Title: **C9010 19DK/DM GROMMET SEAL RETAINER**

Number: **C9010**
Date: **6/25/90**
Supersedes: **NONE**
Date:

Models Affected: **19DK/DM Machines**

TITLE
RETAINER, GROMMET
(COMPRESSOR ASY)

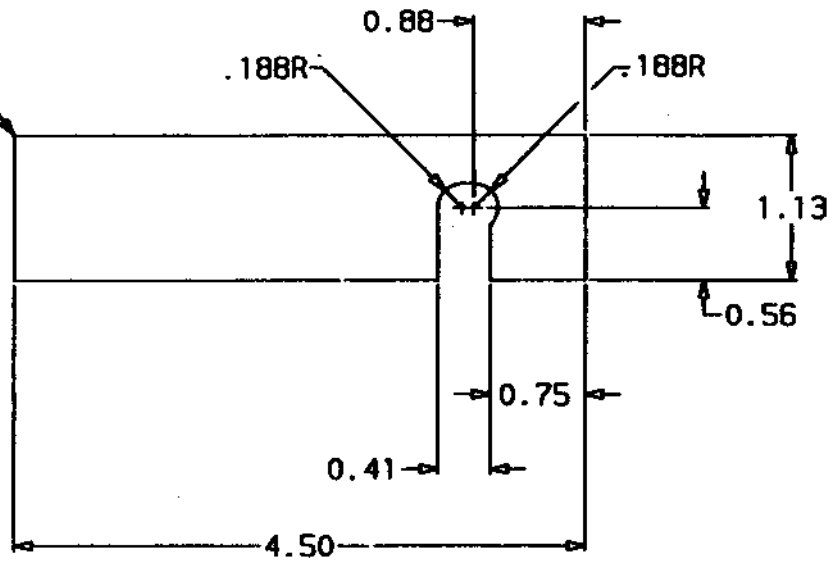
PROCEDURE: The grommet retainer has been designed for ease of installation for all size compressors (see attached drawing). It gets placed on the threaded tube assembly between the 3/8" hex nut washer and the grommet. This retainer is available from RCD. The part number is 19DK 212 1052.

When the entire motor sensor wire assembly is ordered you will find that the threaded tube where all the components are attached has been elongated. The tube has been redesigned from 1 1/4 inches to 1 1/2 inches in length. This has been done to provide more space to accept the new retainer. This new retainer is not included in the wiring harness part number. It must be ordered as a separate item.
